Addendum No. 4

To: International Buddhist Progress Society of Ottawa - Carleton
From: Egis Group Ltd. (formerly McIntosh Perry Consulting Engineers Ltd.)
Date: January 21, 2025
Re: Additional Technical Information to the Revised Geotechnical Report Issued January 2019–
IBPS - 6688 Franktown Rd Richmond

This is an addendum to the revised Geotechnical Report, dated January 2019, which is included in Appendix E. It provides updated recommendations for the foundation design of the proposed temple building, based on the new architectural and civil drawings provided by the International Buddhist Progress Society of Ottawa (the client), which reflect the building's relocation. This addendum must be read in conjunction with the revised report. The additional information and recommendations are presented below. The included information does not replace that which already exists in the revised January 2019 report but serves to augment or update as necessary.

3 SITE PLAN AREA OF DEVELOPMENT
A002 1:400

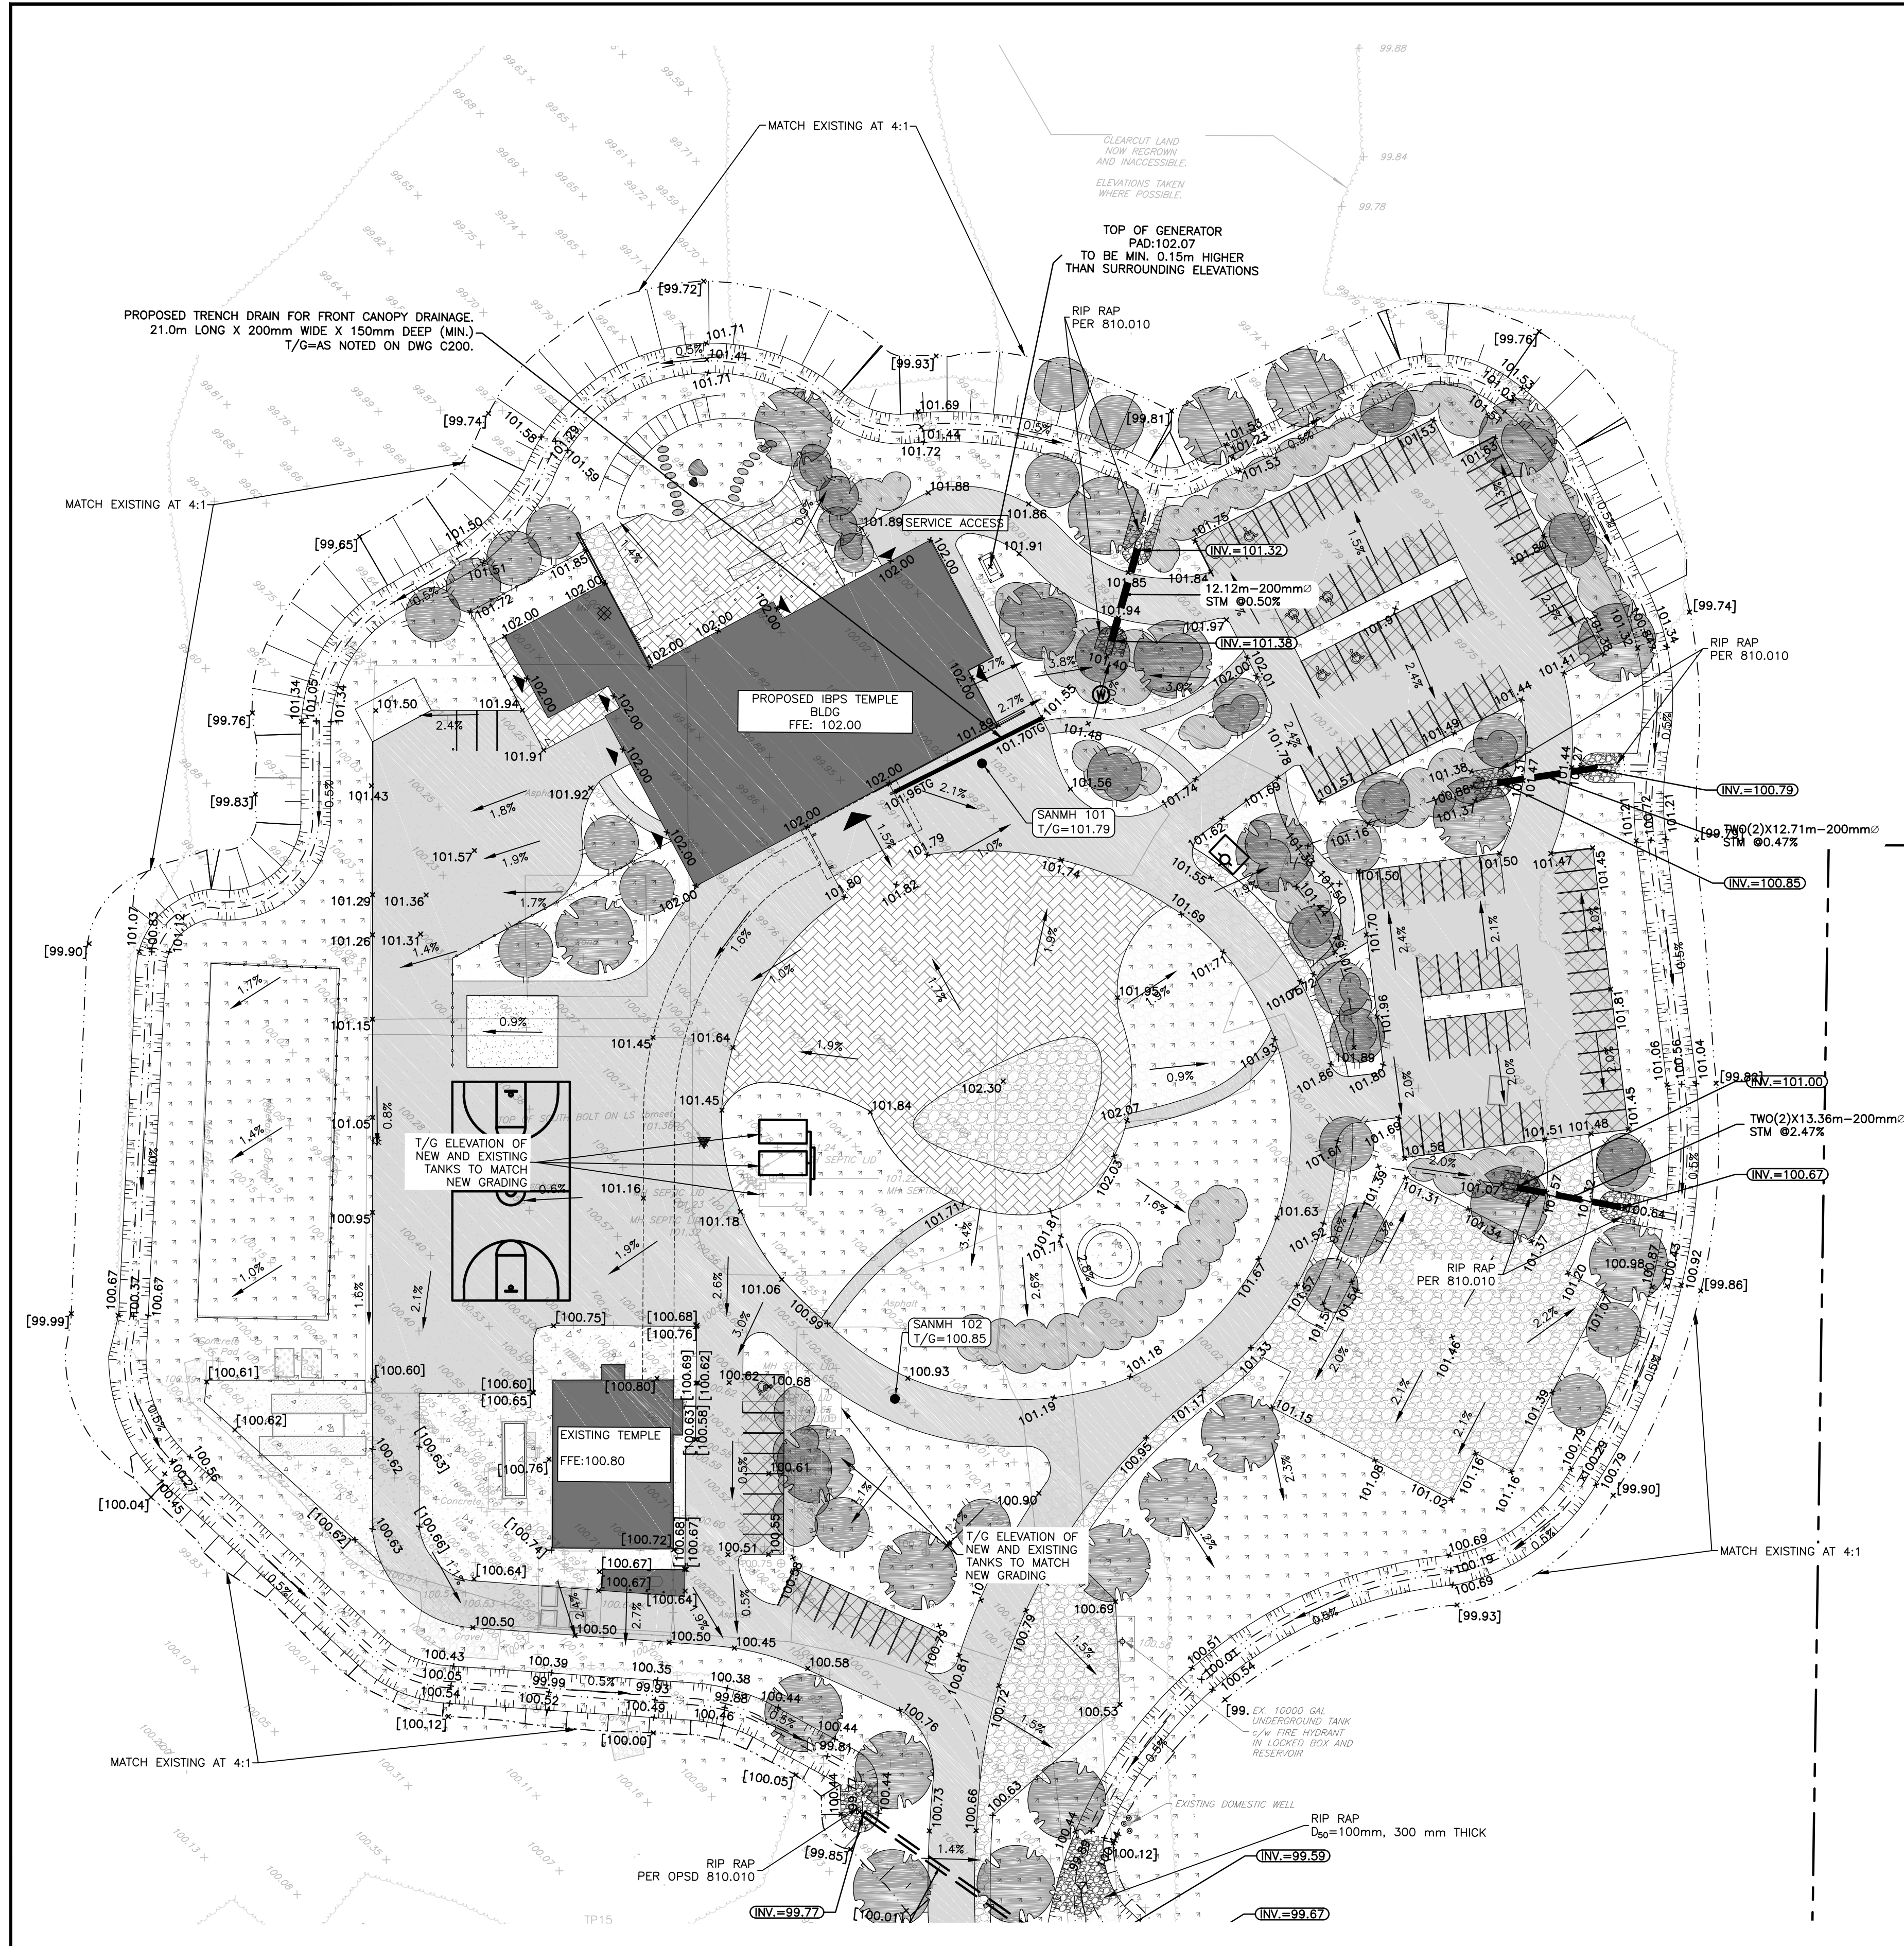
- Based on the architectural site plan A002 Rev. 1 (included in Appendix C), prepared by GRC Architects, dated December 18, 2024, provided by the client, the temple building will be a single-storey structure with no basement, with an approximate footprint of 1,398 m². The new location of the building, as indicated in the site plan, is supported by the borehole data shown in Appendix A. Specifically, boreholes BH18-1, BH18-2, and MW18-1, located within the building footprint, remain valid and provide the necessary geotechnical data for the foundation design.

SITE GRADING PLAN

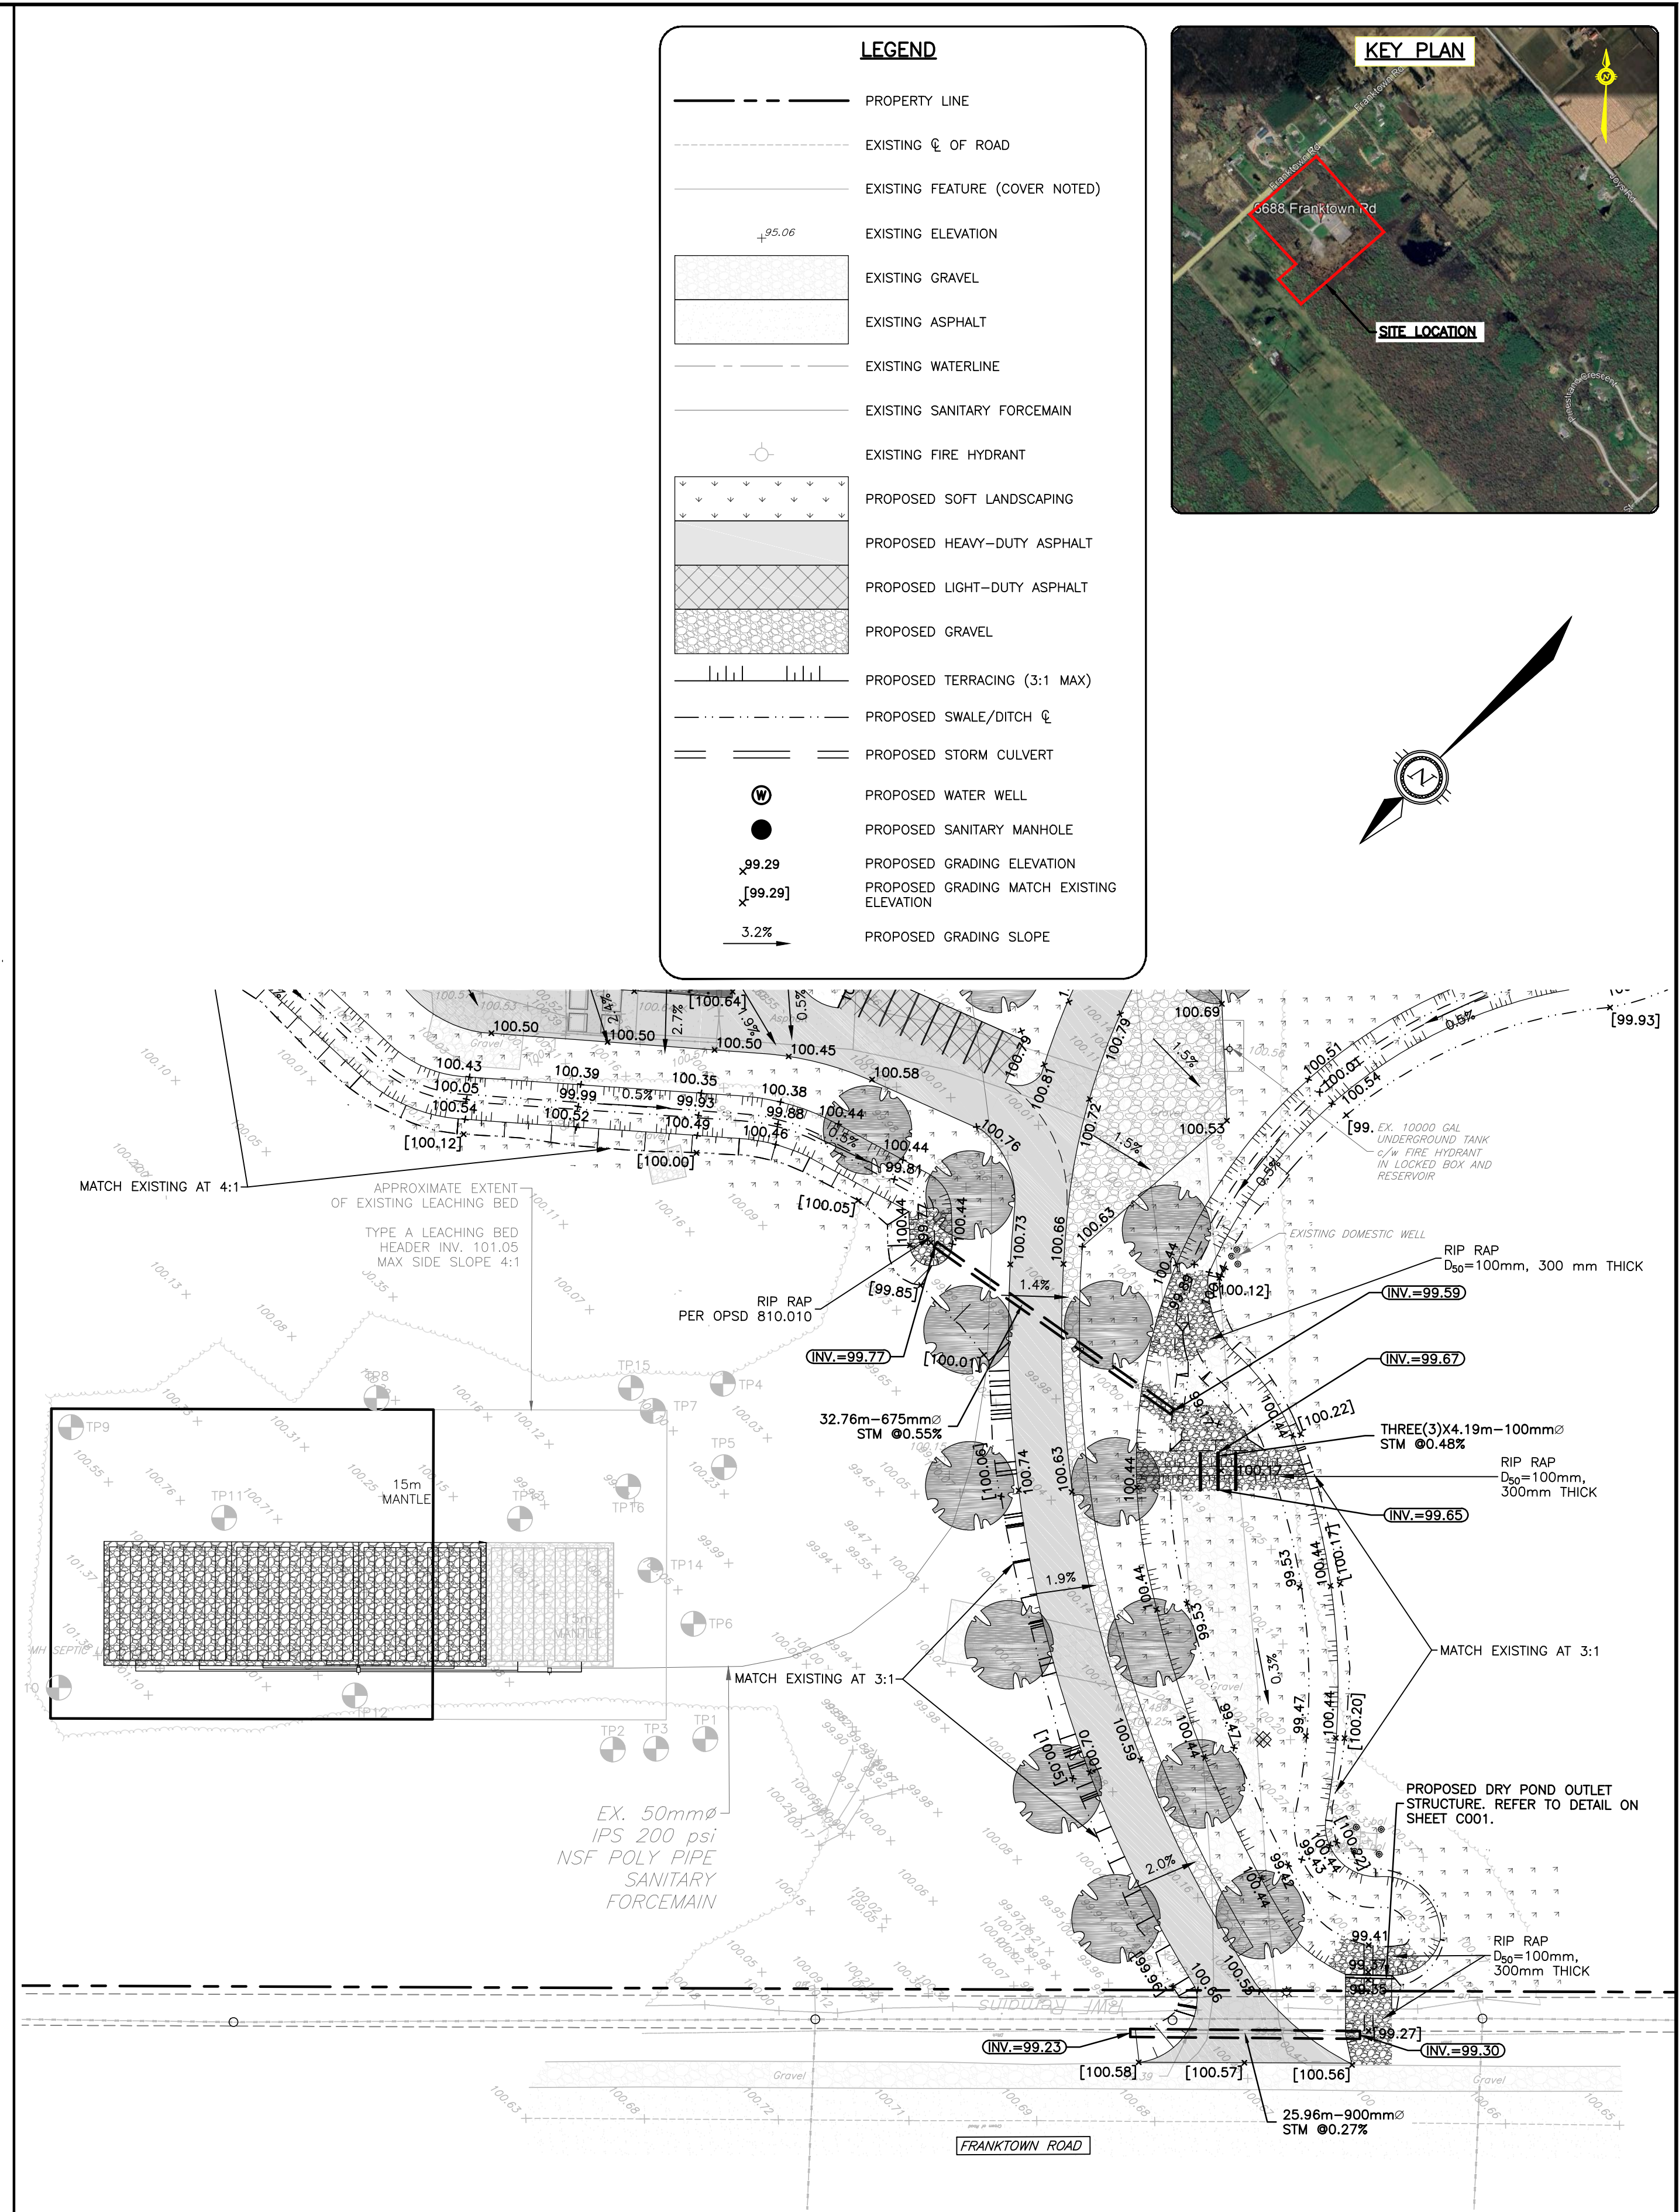
- According to the site grading plan titled C200 Rev. 04 (included in Appendix C), prepared by EXP Services Inc., dated December 18, 2024, provided by the client, the Finish Floor Elevation is set at 102 m asl. The existing site grades beneath the building footprint range from 99.82 m to 100.02 m asl, indicating a grade raise of approximately 2.0 m.
